**Additional Mark to be Displayed Due to Re-compliance With the KS Standard  
(For Products Applied in July 2025)**

Network Products

FA-A-0456-A

## 2 DETAILS ON THE CHANGE

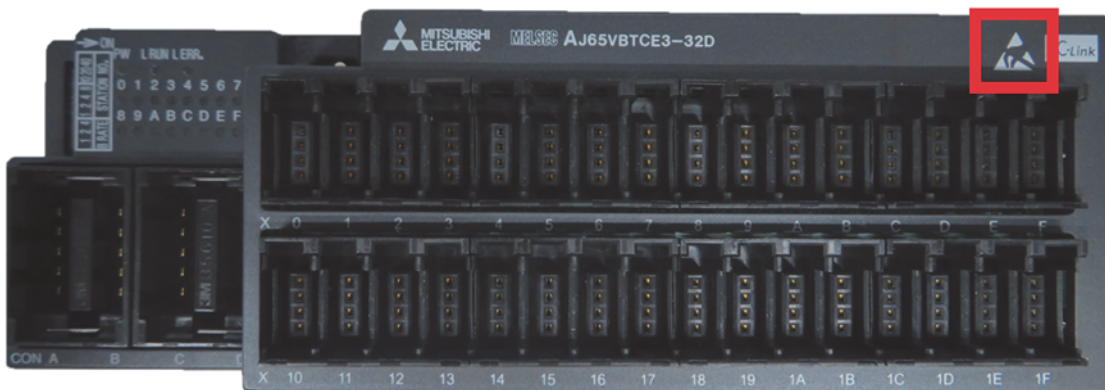
The ESD susceptibility symbol will be added to the rating plate or surface on the module as follows.

Display position varies depending on the module.

The symbol identifies that the electronic component or product is sensitive to static electricity.
